**NAVAL MEDICAL RESEARCH INSTITUTE  
BETHESDA, MARYLAND**

**81 - 47**

**HUMAN ENGINEERING EVALUATION  
OF THE  
HYPERBARIC RESEARCH FACILITY  
(PHASE 1)**

Fig. 23. Removable brackets for bunks in C chamber.

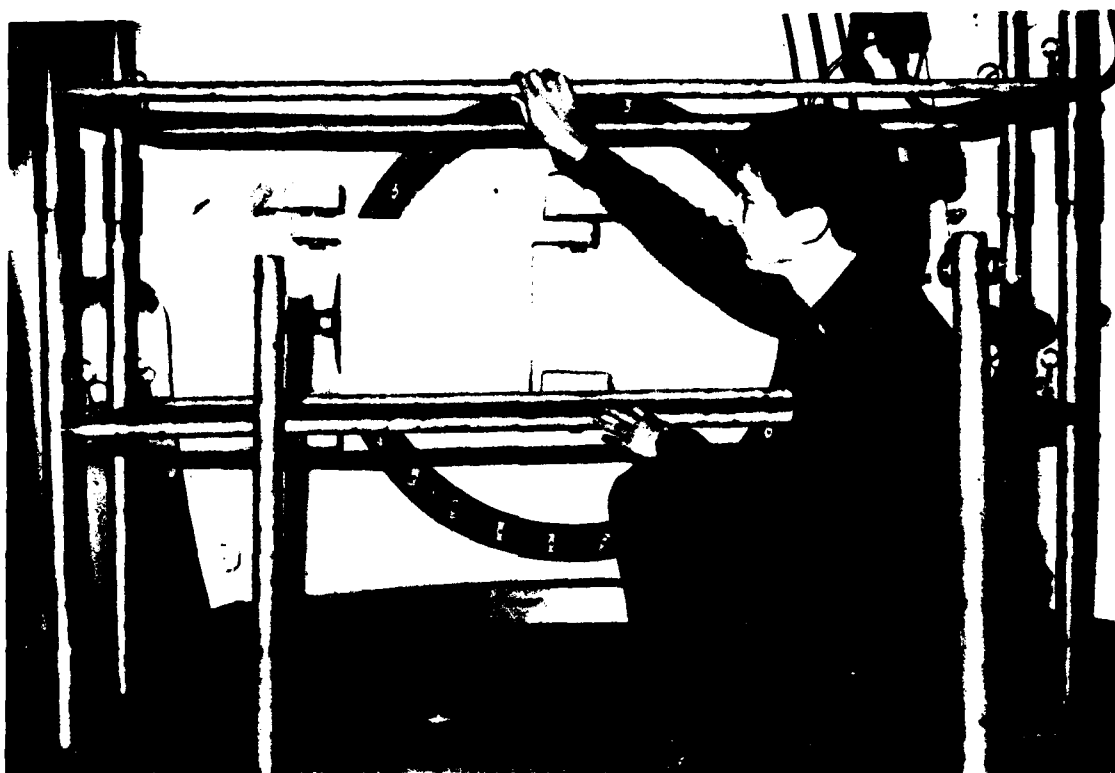
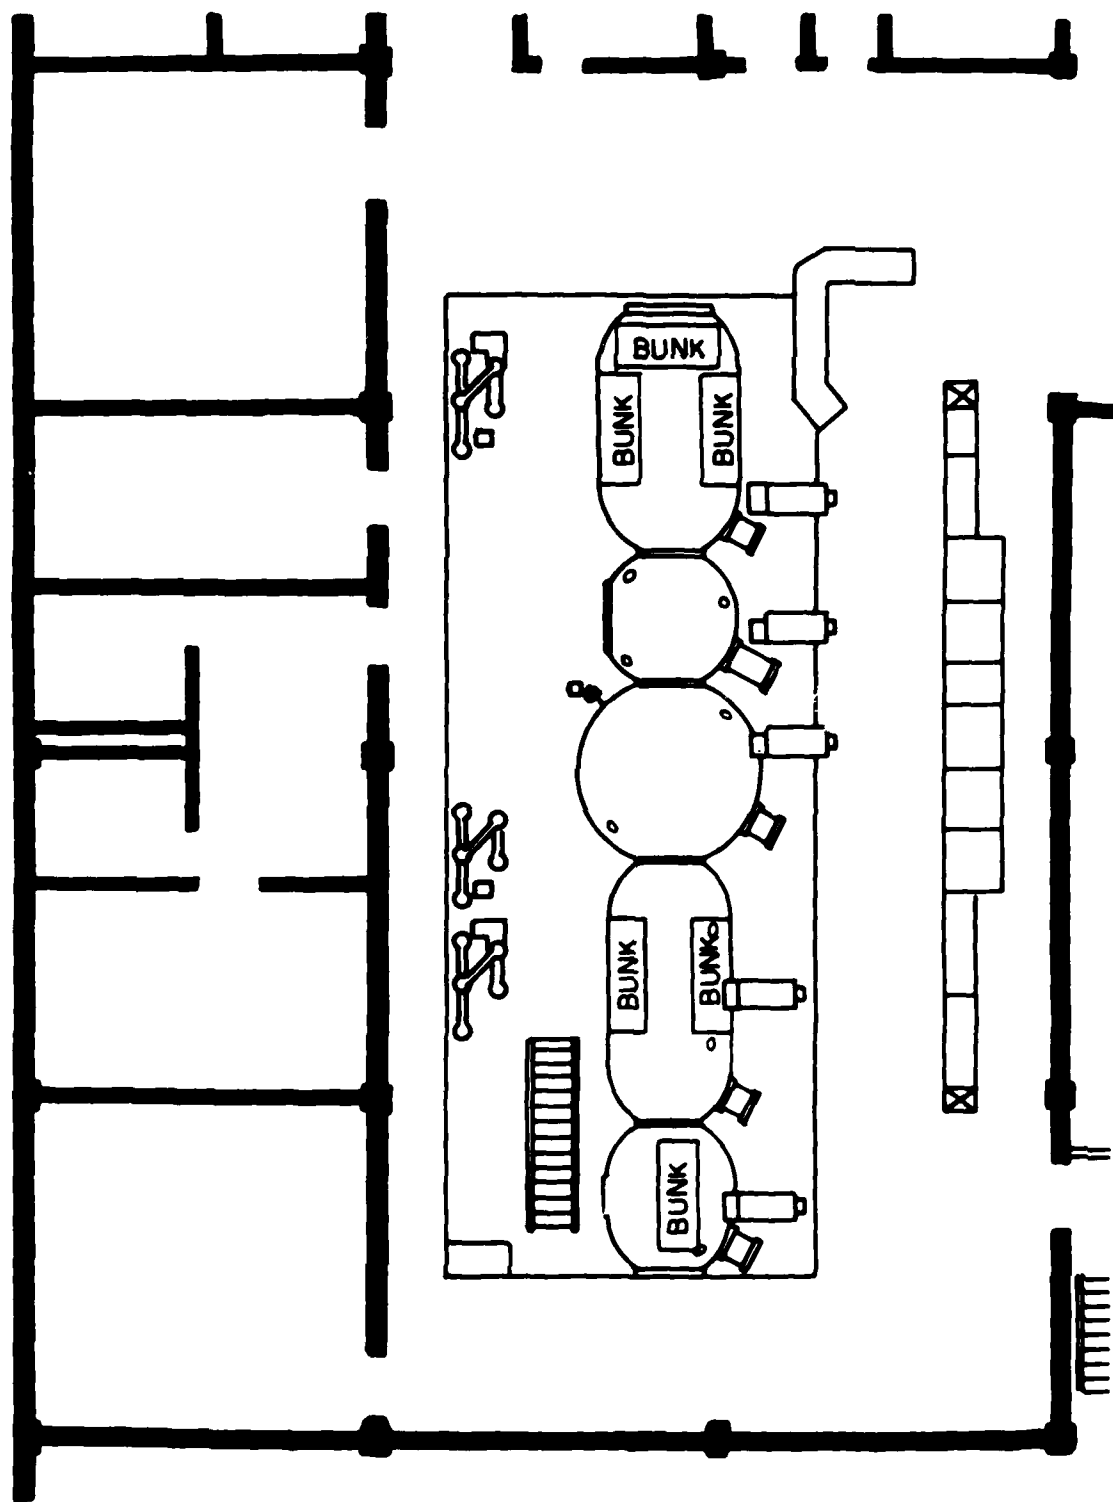
- (38) The removable bunks in C chamber (Fig. 23) should be moved to permanent locations in other chambers. See Fig. 24 for recommended locations. (Priority 2)

Fig. 24. Recommended bunk arrangement when entire complex is at depth.

Fig. 25. Current HRF sanitary holding tank.

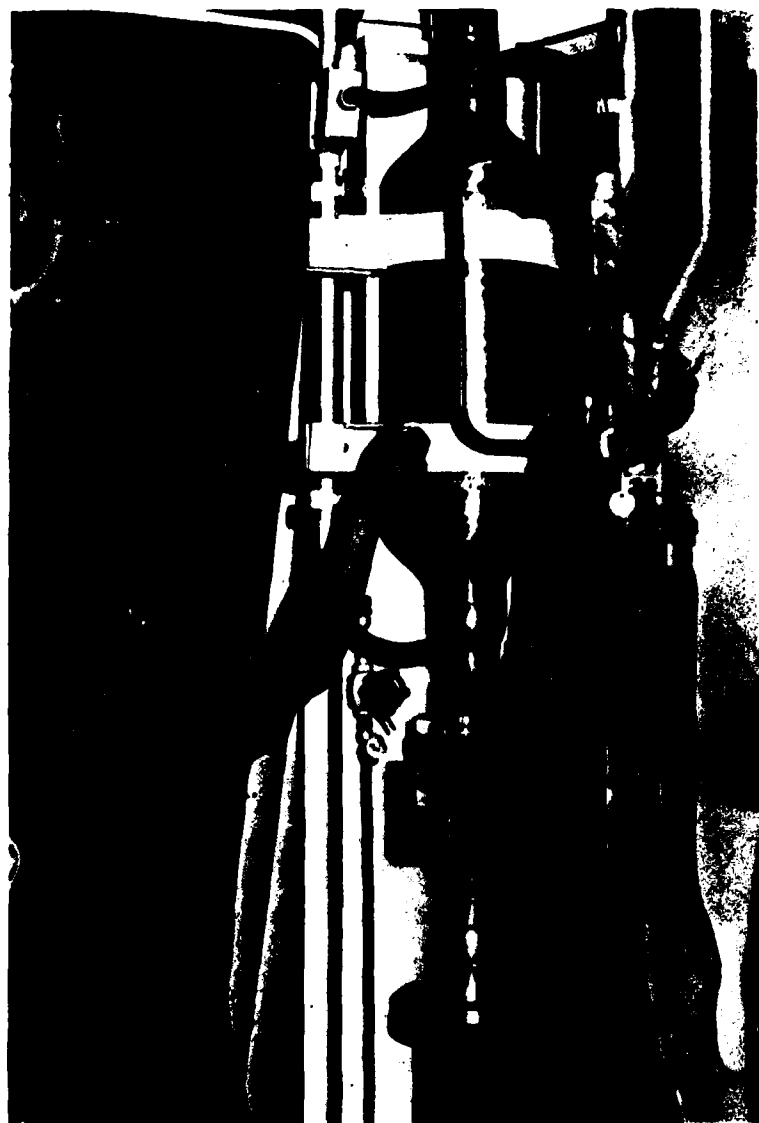
- (40) The current sanitary holding tank is not of adequate volume for frequent showers and toilet flushing (Fig. 25). It is recommended that a larger tank (75 gal) be installed. (Priority 1)

Fig. 28. Present design of the gas analysis patch panel.

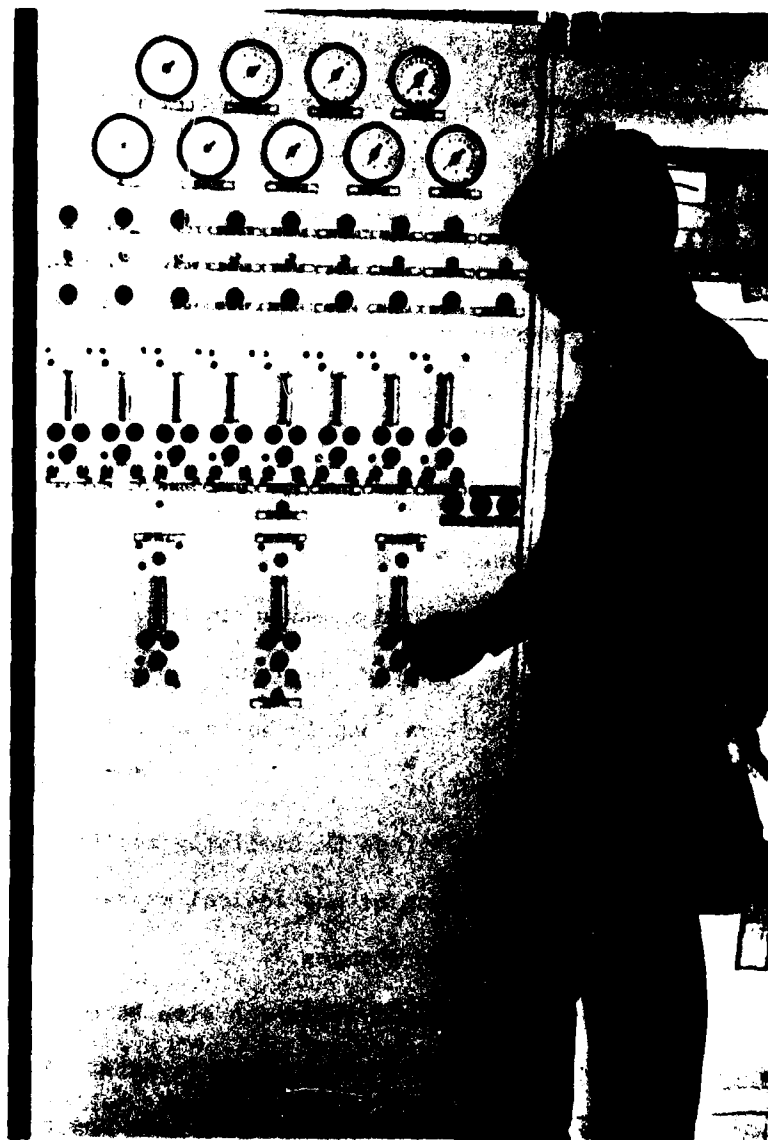
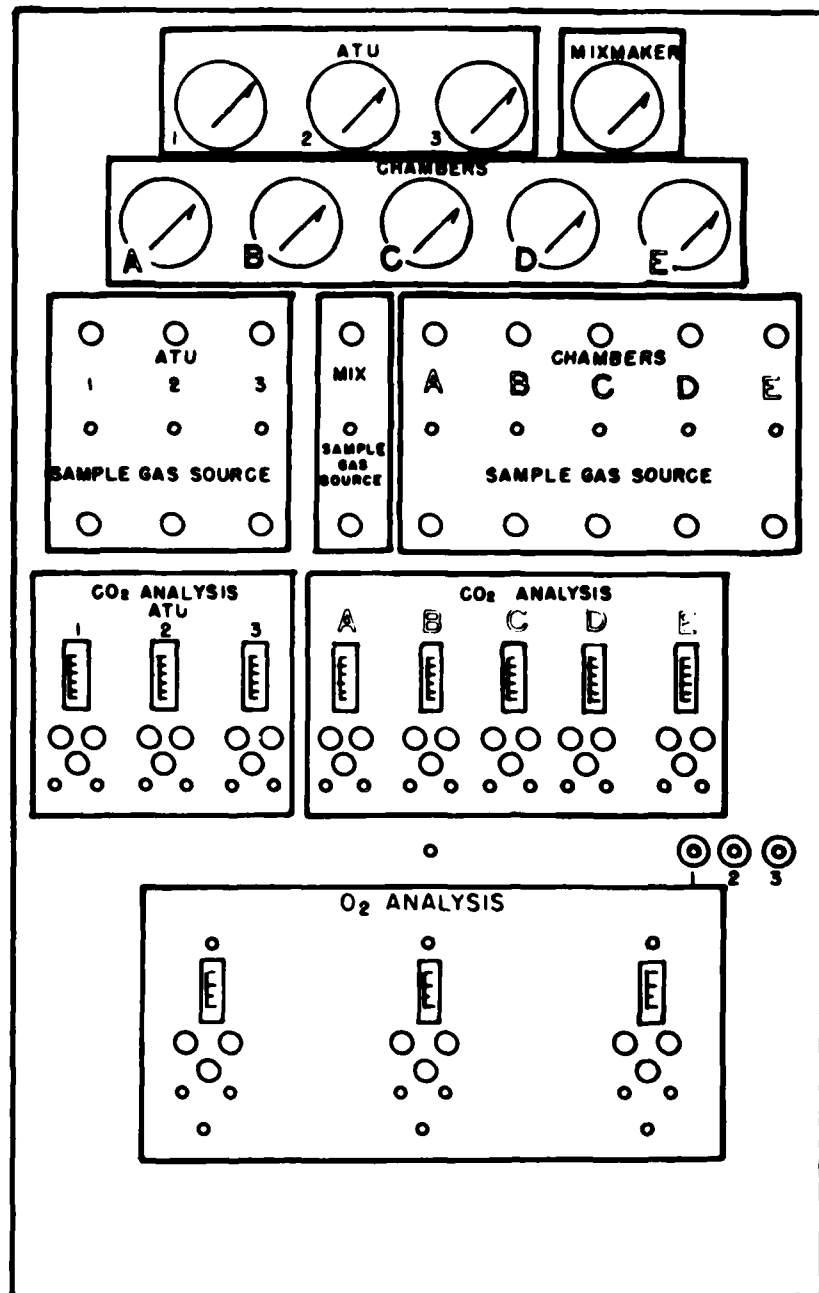
(52) Figure 28 shows the present design of the gas analysis patch panel. As can be seen, no attempt was made to group components by function or to color-code them in a manner to clarify their purpose to an

operator. Figure 29 shows the recommended changes. This layout does not require the movement or alteration of any of the hardware (although several more efficient designs could be devised). It simply employs functional grouping and color coding. This design should improve operator recognition and readability while reducing errors. (Priority 2)

Fig. 29. A proposed layout for the gas analysis patch panel. Gauges and valves are labeled in a simple, easily understandable manner and components of similar function are grouped together graphically and color-coded.

Fig. 30. Present design of gas analysis instrumentation panel.

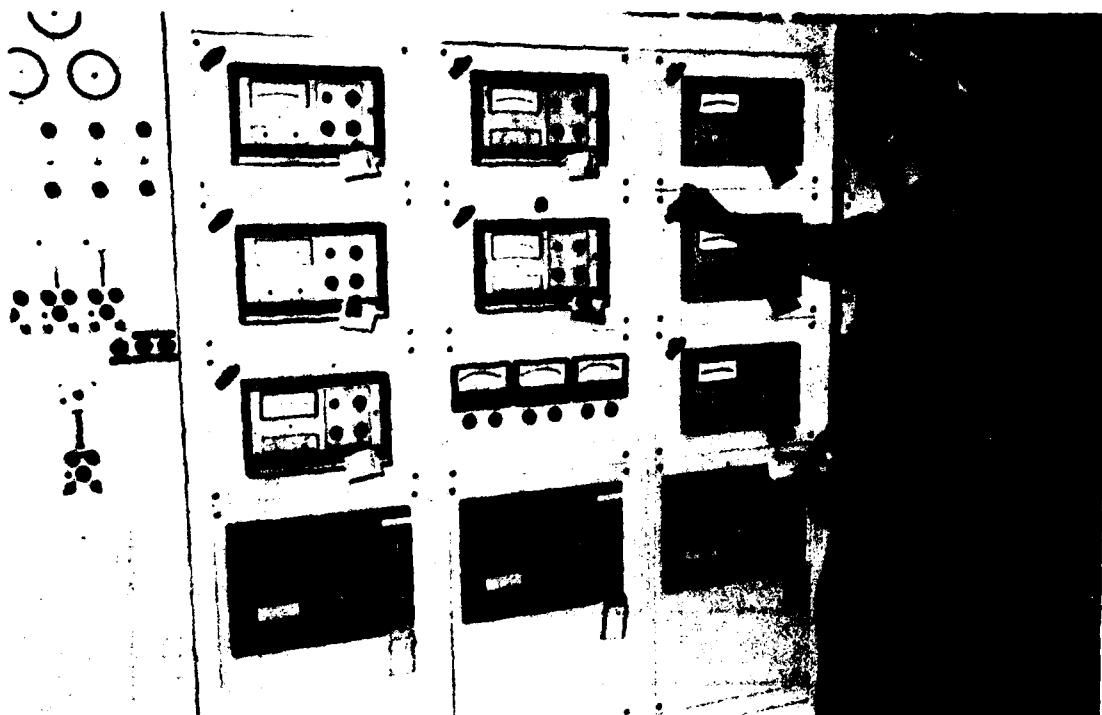
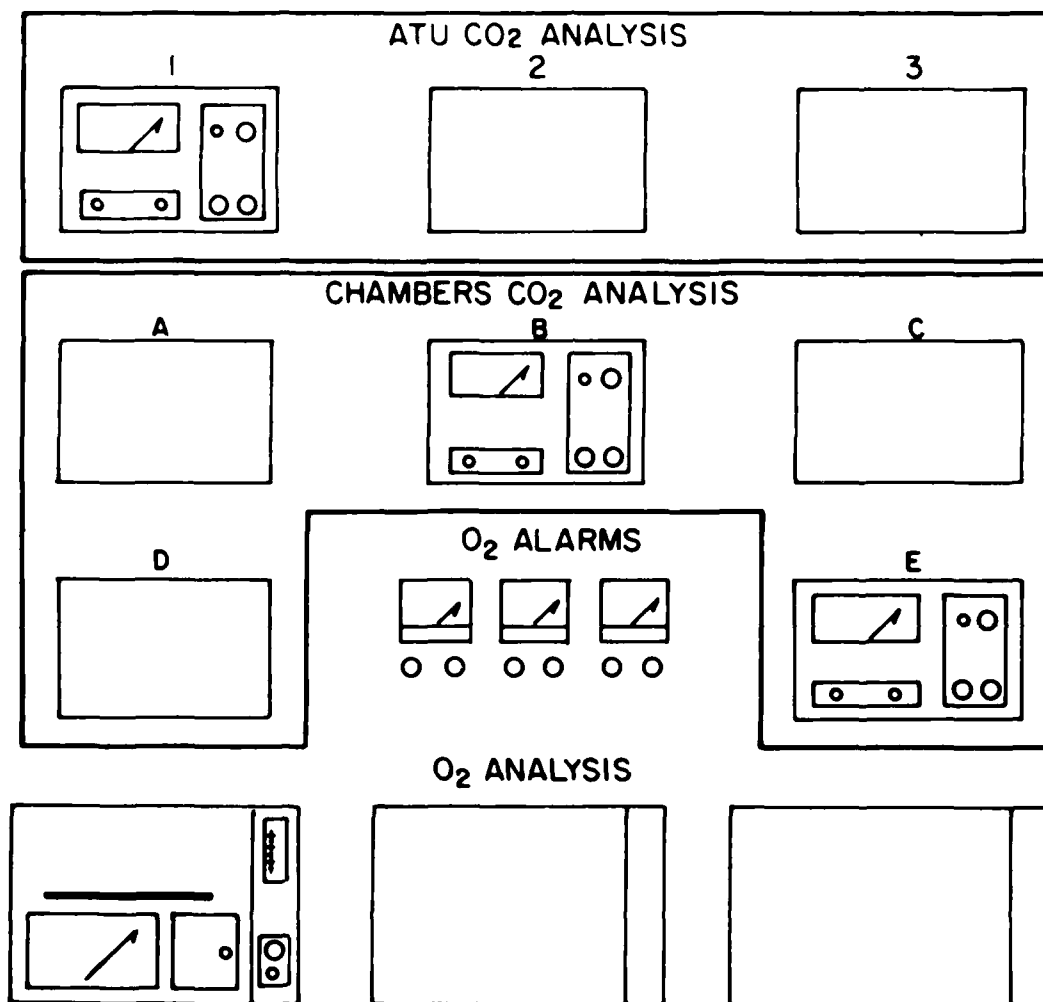
- (53) Figure 30 shows the present gas analysis instrumentation panel. The recommended changes are similar to those above (see Fig. 31). (Priority 2)
- (54) Figure 8 showed the face of a local control panel. Greater clarity of function can be obtained by concise gas paths and simple noncoded labeling. The recommended scheme is shown in Fig. 32. (Priority 2)

Fig. 31. A proposed layout for the gas analysis instrumentation panel. Again, functional grouping, color-coding, and large simplistic labeling have been employed to improve readability and decrease recognition time.

Fig. 33. Current configuration of a master console operating panel.

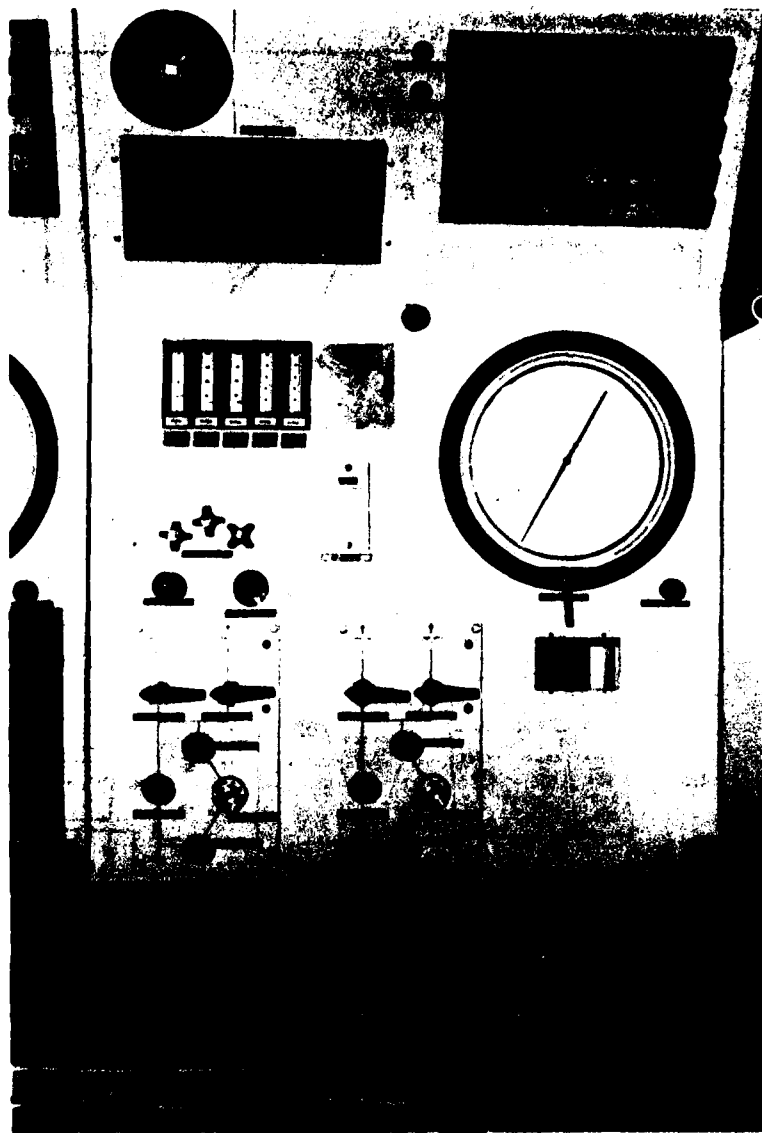
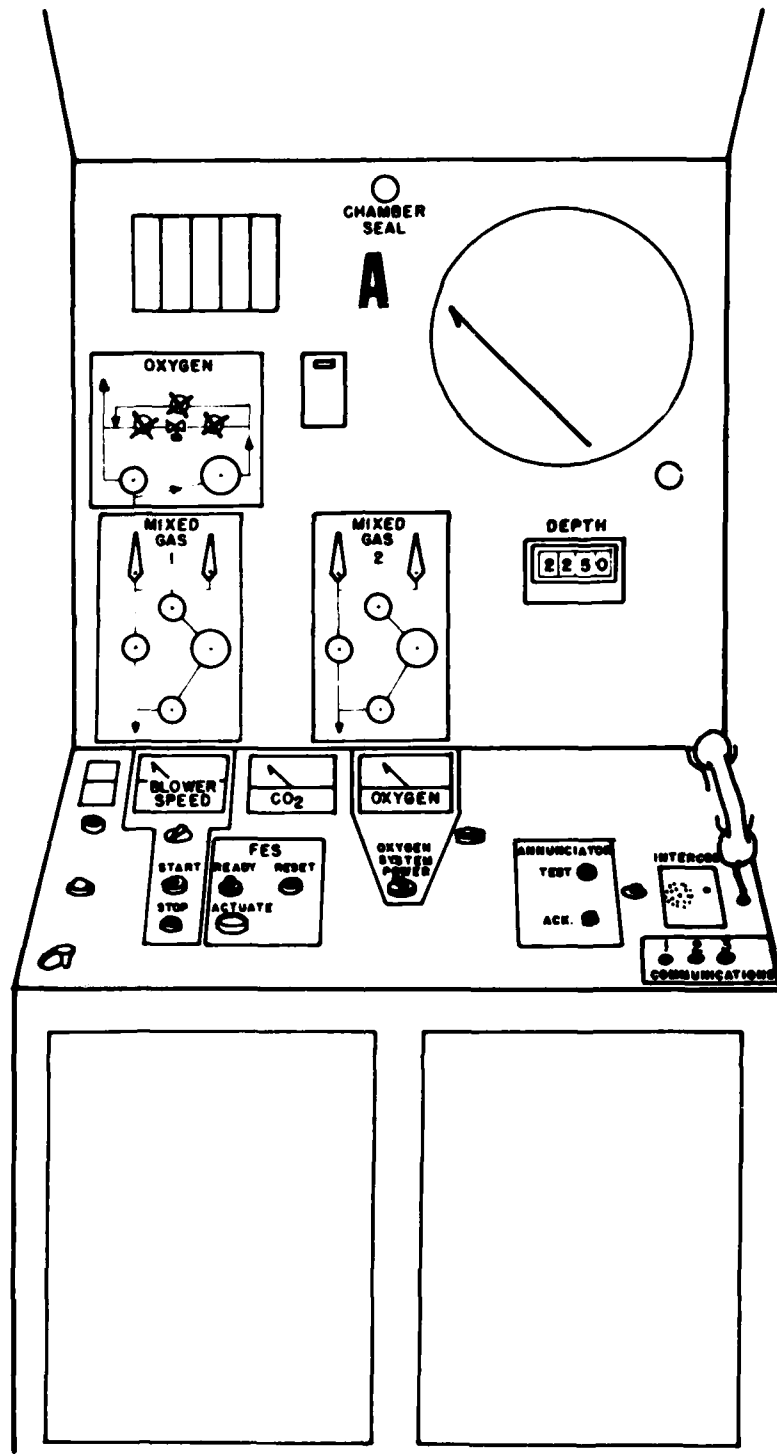
- (56) The operating panels (Fig. 33) can be similarly modified to improve their organization in a meaningful and logical manner. Figure 34 shows a layout for recommended changes. (Priority 2)

The HRF's present annunciator panels (shown in the upper portion of Fig. 33) provide equipment status as well as emergency information via both visual and auditory alarms. When certain conditions are "sensed," a flashing component of the annunciator panel is activated which displays the appropriate information. Simultaneously, a loud intermittent auditory beep is sounded. When the operator acknowledges the alarm with a pushbutton, the auditory alarm stops and the flashing visual display becomes continuously lit until the alarm condition is rectified. This particular approach to alarm recognition is a good one, provided frequent inconsequential information is not being displayed in this manner. If inconsequential information is presented, an operator's response to the alarms is gradually slowed as alarm adaptation occurs. Without requiring the need of quick response, the

Fig. 34. A proposed layout for the operating panels.

It is recommended that an emergency annunciator panel be installed in the central monitoring console so that the dive supervisor and dive officer have easy visual access to it. (Priority 2)
